Product / Process Change Notification (PCN)	
<input type="checkbox"/> Major Change <input checked="" type="checkbox"/> Minor Change	
PCN Number: PCN_WCAP-CSSA_20241129 Affected Series: WCAP-CSSA Affected Order Codes: 8853520100011, 8853520100071, 8853520100111, 8853520100201, 8853522100131, 8853522100141, 8853522110011, 8853522110021, 8853522110031, 8853522130111, 8853522130151, 8853522140011, 8853522140021, 8853620100091, 8853620100111, 8853620100171, 8853620100181, 8853622100091, 8853622100131, 8853622100171, 8853622100181, 8853622110111, 8853622110151	Change Category: <input type="checkbox"/> Equipment/Location <input checked="" type="checkbox"/> General Data <input type="checkbox"/> Material <input type="checkbox"/> Process <input type="checkbox"/> Product Design <input type="checkbox"/> Shipping/Packaging <input type="checkbox"/> Supplier <input type="checkbox"/> Software

PCN Date: 2024-08-29 (YYYY-MM-DD) Effective Date: 2024-11-29 (YYYY-MM-DD)	
Contact: Product Management Phone: +49 (0) 7942 - 945 5001 Fax: +49 (0) 7942 - 945 5179 E-Mail: pcn.eisos@we-online.com	Datasheet Change: <input checked="" type="checkbox"/> Yes <input type="checkbox"/> No Attachment: <input type="che

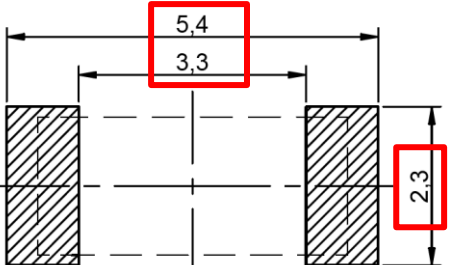
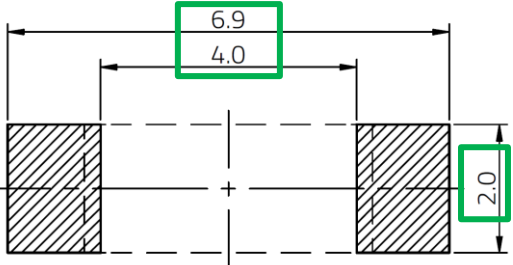
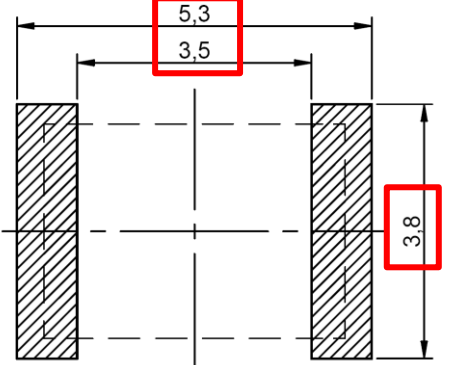
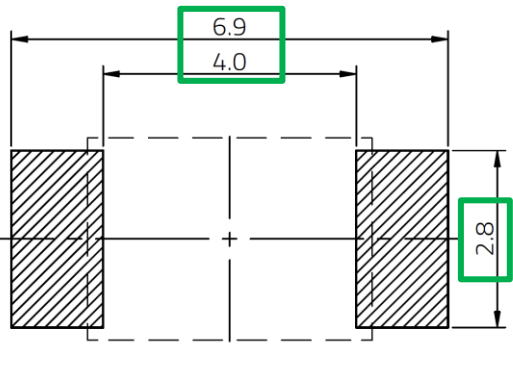
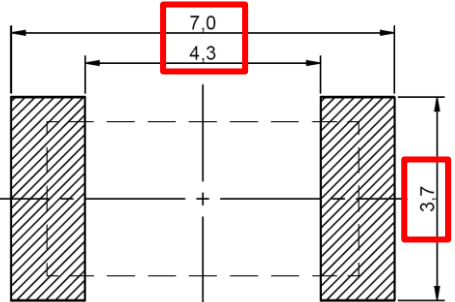
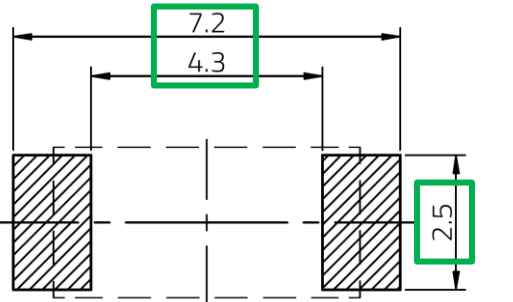
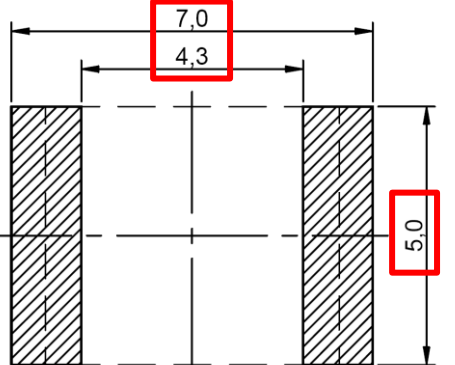
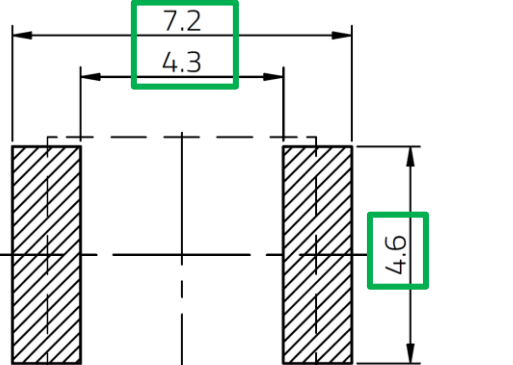
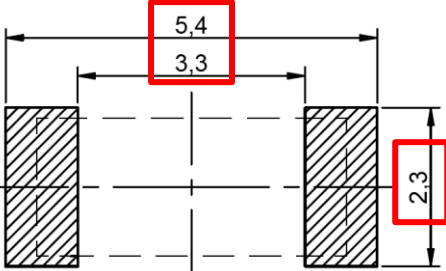
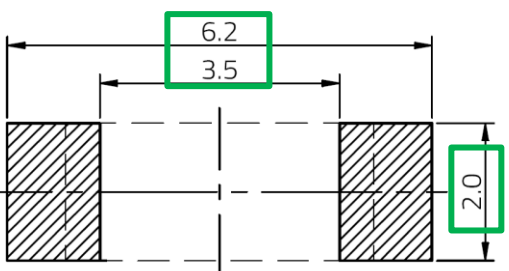
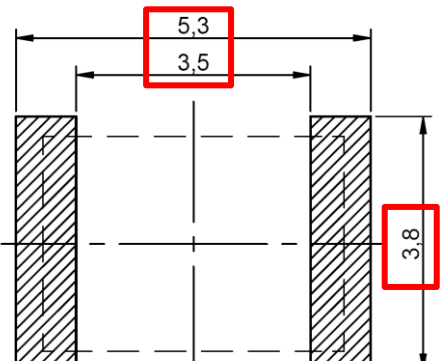
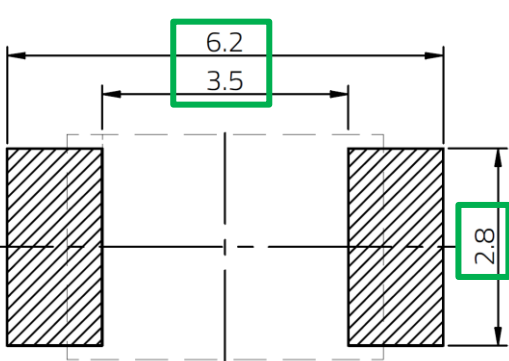
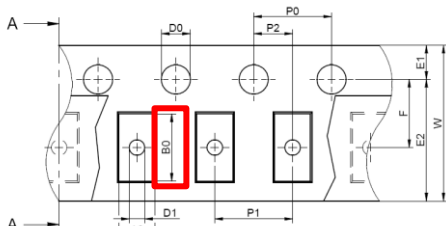
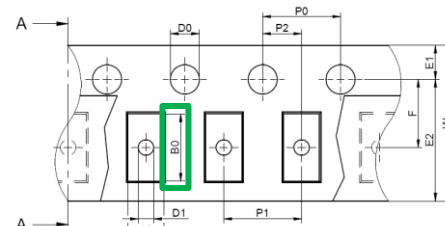
- Correction of the dimension specification. Corrected dimensions and tolerances are marked with a red box **before change** and green box **after change**.

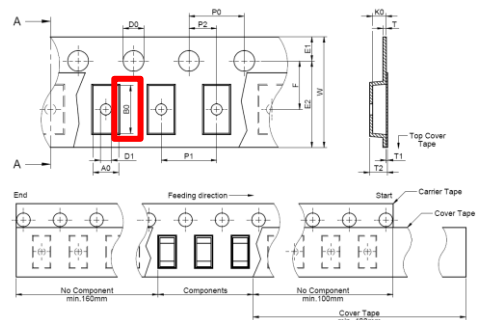
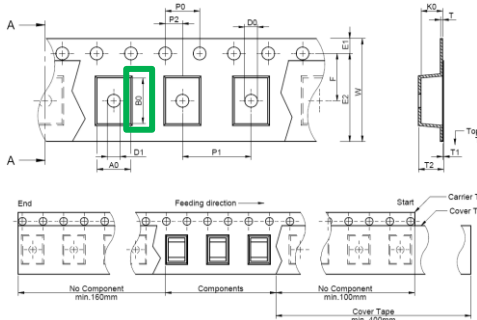
2. Correction of the Recommended Land Pattern specification. Corrected specifications are marked with a red box **before change** and green box **after change**.

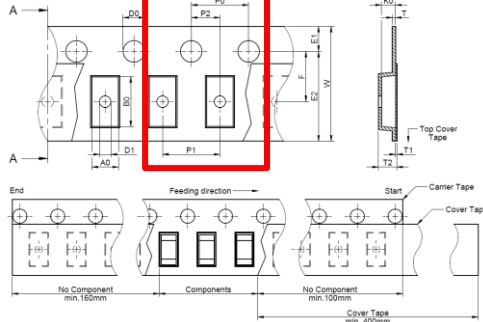
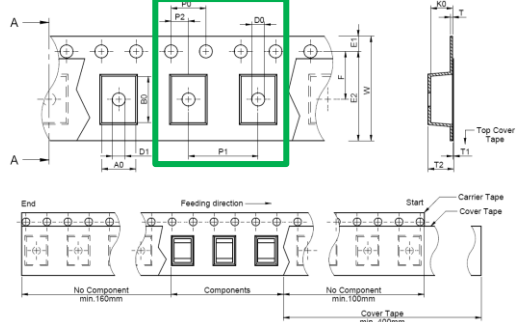
4. Correction of the packaging drawing. Corrected drawing is marked with a red box before change and green box after change.
